AMENDMENTS TO THE CLAIMS

REMARKS

FIG. 17A

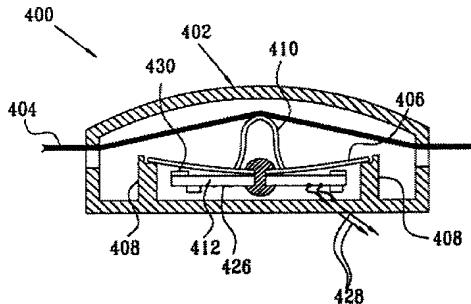
Fig. 17B has been currently amended to remove a reference numeral 414, which was included in error. A replacement drawing sheet, including Fig. 17B as currently amended is attached to this communication.

This embodiment is illustrated in Figs. 17A-B of the application, which show:  
a deformable plate 406 (the deformable electrode), which is conductive on at least one large surface thereof; and

a conductive layer 414 (the base electrode), which is printed on a plate 412.

Conductive layer 414 is shown in dark black lines in Fig. 17B. An insulating layer 418 (shown in vertical hash lines) prevents contact between deformable electrode 406 and conductive layer 414. As described in the application, "Deformable plate 406 and counter plate 412 are preferably compressed and fixed by a fixing pin 420." Fig. 17A shows that the shortest distance between the deformable electrode 406 and the base electrode 414 varies along the length of the deformable electrode. The base electrode and the deformable electrode converge at their central portions (i.e., at a fixed-region along the length of the base electrode) where (a) they are at their closest

Claims 188 and 289 have additionally been amended to recite that the deformable electrode is supported by a deformable-electrode supporter at a support region that is remote from the fixed region. Deformable-electrode supporters 408 are shown in Fig. 17A to support the deformable electrode 406 at a region (at the ends of the deformable electrode) that is remote from the fixed region (at the center of the deformable electrode).

FIG. 1

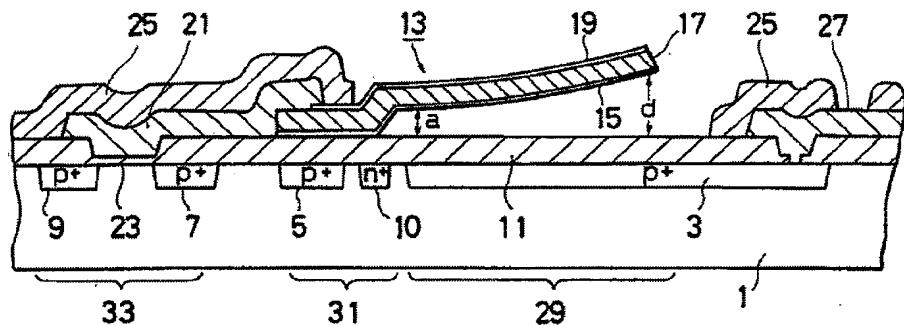
9. Claims 189, 192, 194, and 288 are rejected under 35 U.S.C. 102(b) as being anticipated by Hoshino (USP #4,672,849).

10. As to claims 189 and 288, Hoshino teaches an apparatus comprising a housing (Fig. 1), a base electrode (1), a deformable electrode (13) mechanically coupled to the base electrode and the housing, the base electrode and the deformable electrode defining a capacitor having capacitance, such that the capacitance is varied responsive to deformation of the deformable electrode (col. 4 lines 38-65), wherein when no force is applied to the deformable electrode and the distance between the base and deformable electrode varies along a length of the deformable electrode, the two electrodes converging to a closest possible distance from each other, which is fixed by the apparatus (Fig. 1).

The Examiner stated that (a) the cantilever of the Hoshino patent corresponds to the deformable electrode of the present application, (b) substrate 1 of the Hoshino patent corresponds to the base electrode, (c) the distance between the deformable electrode and the base electrode varies along the length of the deformable electrode, and (d) the deformable electrode and the base electrode converge to a closest possible distance from each other which is fixed by the apparatus.

supporter, as recited in Claims 189 and 288 of the present application, is novel and non-obvious over Hoshino. **Hoshino does not disclose a supporter for supporting cantilever 13 at a support region that is remote from a fixed region, at which fixed region the deformable electrode and the base electrode converge.** Furthermore, if a deformable-electrode supporter, as recited in Claims 189 and 288, was incorporated into the device of the Hoshino patent, then the device would not function as it is supposed to function. The device shown in Fig. 1 of Hoshino is a vibration-detecting structure. As stated in Hoshino's Abstract "the cantilever of the vibration detecting structure **vibrates well** but never hits the surface of the semiconductor substrate, thus **enabling a wide rage of mechanical vibrations to be detected with a high sensitivity.** (emphasis added)" If a deformable-electrode (i.e., cantilever) supporter were to be placed at a site that is remote from the fixed region, then the cantilever would not vibrate. For example, if a supporter were placed where the arrow labeled "d" appears in Fig. 1 of Hoshino, it would prevent the cantilever from vibrating. Therefore, it would not be obvious to combine a deformable-electrode supporter, as recited in Claims 189 and 288 of the present application, with Hoshino, since the incorporation of the supporter into the Hoshino device would prevent the Hoshino device from performing its intended function.

FIG. 17A

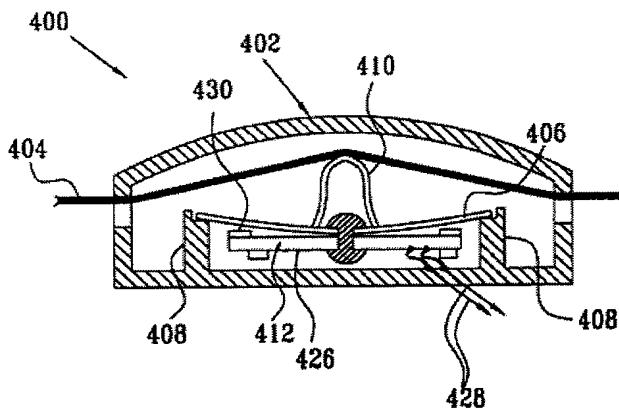
Claims 189 and 288 of the present application have been amended to recite a deformable-electrode supporter configured to support the deformable electrode at a support region that is remote from the fixed region. The deformable electrode supporter of Claims 189 and 288 of the present application is shown, for example, in Fig. 17A (reference numeral 408) of the present application:
